We warmly thank the two reviewers for their relevant and useful feedback and comments on our paper titled "Constraining pesticide degradation in conceptual distributed catchment models with compound-specific isotope analysis (CSIA)." We have now carefully addressed and incorporated these comments to emphasize the originality and potential of this study.

Reviewer 1:

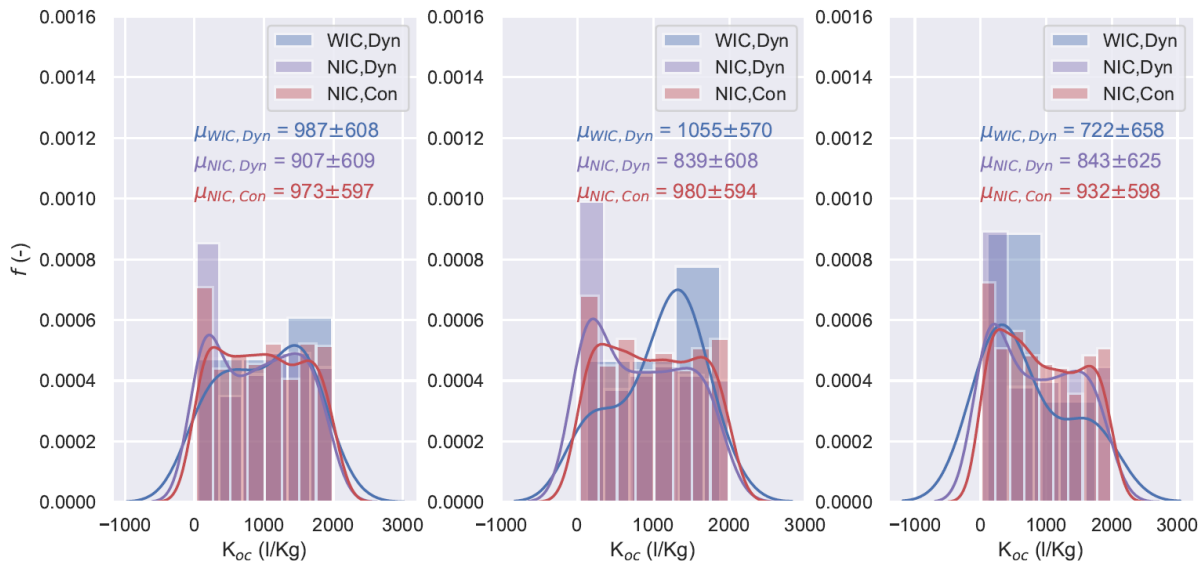
**Ln 420** OK WIC calibration reduced uncertainty, but what happens with the other 24 parameters? In the case of NIC or WIC calibration, do they maintain the uncertainty bounds? Or perhaps it changes, and how? This is important to analyze because that uncertainty may be translated to other parameters. Additionally, is there some field (laboratory) information on the common parameter values for this compound? especially DT50. I agree that DT50 could be one order of magnitude different from the expected one. Still, it is welcome to have the laboratory reference to see if calibration did not modify parameters to “unexplainable” values. That also holds for the 24 remaining parameters that you calibrate. That kind of analysis is expected from this kind of research.

We hypothesized that  $DT_{50, \text{reference}}$  was the primary parameter affected by incorporating stable isotope signatures, as it is the sole parameter governing degradation in PiBEACH. As expected,  $DT_{50, \text{reference}}$  was affected. Specifically, its uncertainty bounds were reduced when  $\delta^{13}\text{C}$  was included in the objective function (WIC calibration). The newly calibrated WIC range for  $DT_{50, \text{reference}}$  ( $18 \pm 4$  days) remained consistent with reported experimental values in the literature. In contrast, the uncertainty bounds for the other 24 parameters were not significantly altered when comparing NIC and WIC calibrations (data not shown in the current version).

In response to the Reviewer’s comment, we have now added a new section in the Supplement (Section 12). This includes a new Figure S8, demonstrating, using  $K_{OC}$  as an example, that CSIA data (WIC) did not reduce the uncertainty of 24 other parameters compared to NIC. This may be due to the pesticide extraction protocols used for soil samples, which account for both the dissolved phase and the extractable sorbed phase. Additionally, sorption generally does not lead to significant isotope fractionation (see also the response to Questions 2 and 3 in the Introduction, addressed by Reviewer 2). In this case, CSIA may not help evaluate sorption and thus constrain  $K_{OC}$  values as isotope signatures for pesticides in the dissolved and particulate phase of soil samples are generally similar.
